# SRRTEP COMMITTEE: MID-ATLANTIC PSE&G SUPPLEMENTAL PROJECTS

February 16, 2023

# **PSE&G Supplemental Project S2491 Scope & Cost Update**

# PSEG Transmission Zone M-3 Process Elizabeth Area

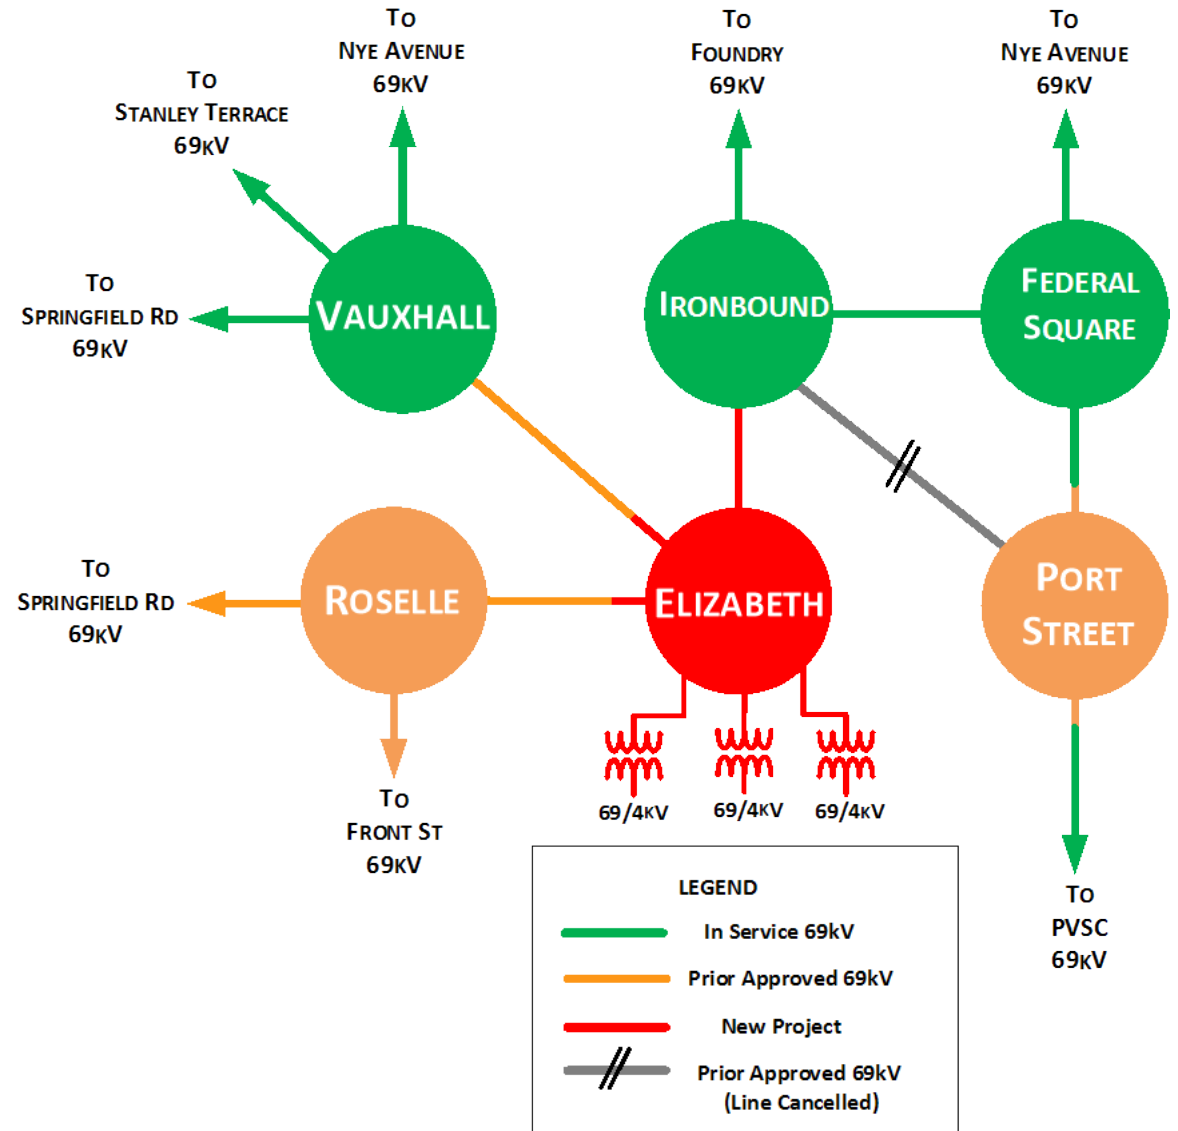
**Update:** Siting Challenges have resulted in solution refinements as follows:

- Convert existing Elizabeth 26/4kV substation to a 69/4kV substation
  - Purchase property to accommodate new construction.
  - Install 69kV substation with three (3) 69/4kV transformers.
  - Cut and loop Linden-Roselle -Vauxhall 69kV circuit into new location.
  - Construct a circuit to ~~Nye Ave 69kV~~ Ironbound 69kV
  - Eliminate s0934.4 (69kV line between Ironbound and Port Street)
  - **Estimated Cost:** ~~\$85.8M~~-\$97.8M

- Resolves siting challenges for Port Street project.
- Resolves significant challenges to the Port Street project due to other infrastructure work by third parties in the area.
- Avoids the need to acquire additional land and undertake environmental cleanup that would significantly increase the cost to the Port Street project.
